STC Modification Proposal Form

CM085: To clarify OFTO reactive power requirements at <20% output

Overview: It is unclear what the requirements are on OFTOs to provide access to reactive power capability at low windfarm outputs. This modification seeks to clarify that where reactive capability is available it should be provided which is operationally useful to the ESO.

Figure ECC.6.3.2.4(c)

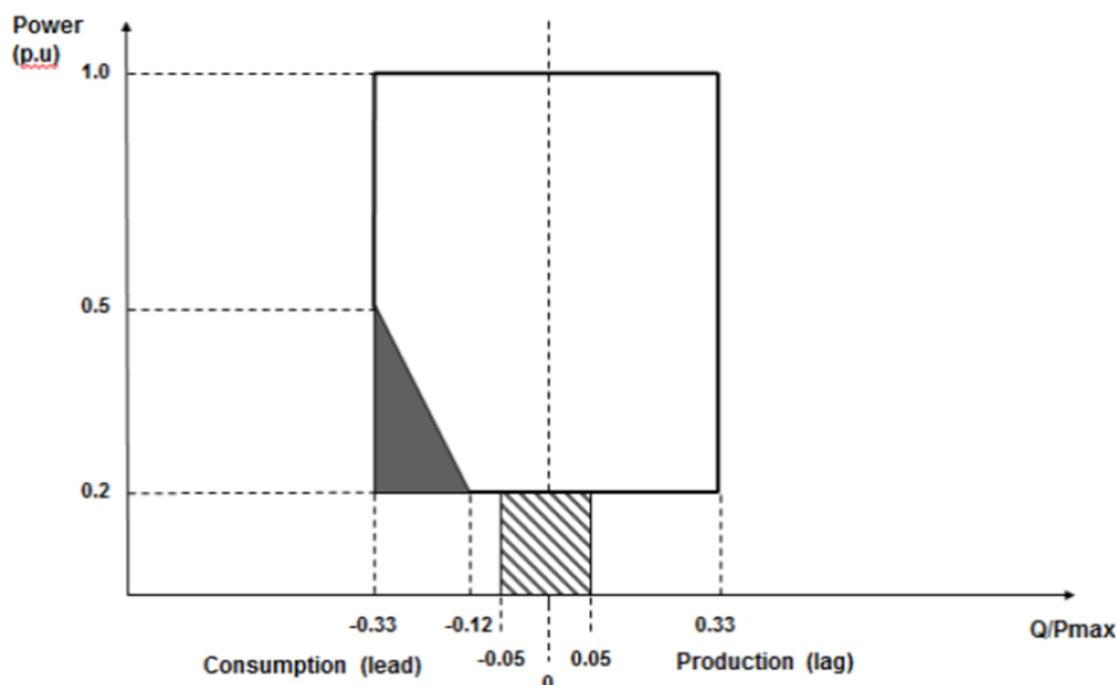
This diagram sets out the expected operating envelope for a power park module in terms of its reactive range at varying active power outputs, being expressed as a maximum requirement (the thick black line) down to 20% of active power output. Further details are in the text (ECC6.3.2.4.4) which accompanies the diagram.

The two shaded areas are not within the expected requirement for PPMs and there is not a definitive reactive requirement below 20% output for PPMs although ECC.6.3.8.4.1 states:

'When operating below 20% Maximum Capacity the automatic control system may continue to provide voltage control using any available reactive capability. If voltage control is not being provided, the automatic control system shall be designed to ensure a smooth transition between the shaded area below 20% of Active Power output and the non-shaded area above 20% of Active Power output.'

Figure K1

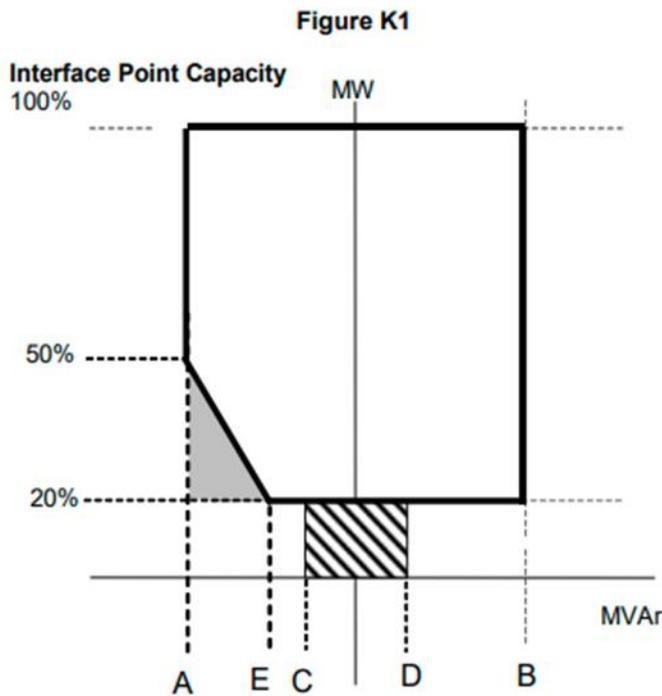
2.4 When transferring Active Power equivalent to less than 20% of the Interface Point Capacity:

2.4.1 the automatic control system ~~may~~ shall continue to provide voltage control utilising any available reactive capability and, if applicable, as instructed by The Company;

2.4.2 If voltage control is not being provided:

(a) the automatic control system shall be designed to be capable of a smooth transition between the shaded area bounded by CD and the non-shaded area bound by AB in Figure K1 below; and

(b) the Reactive Power delivered at the Interface Point shall be within a range of +/-5% of the Interface Point Capacity expressed in MVar.
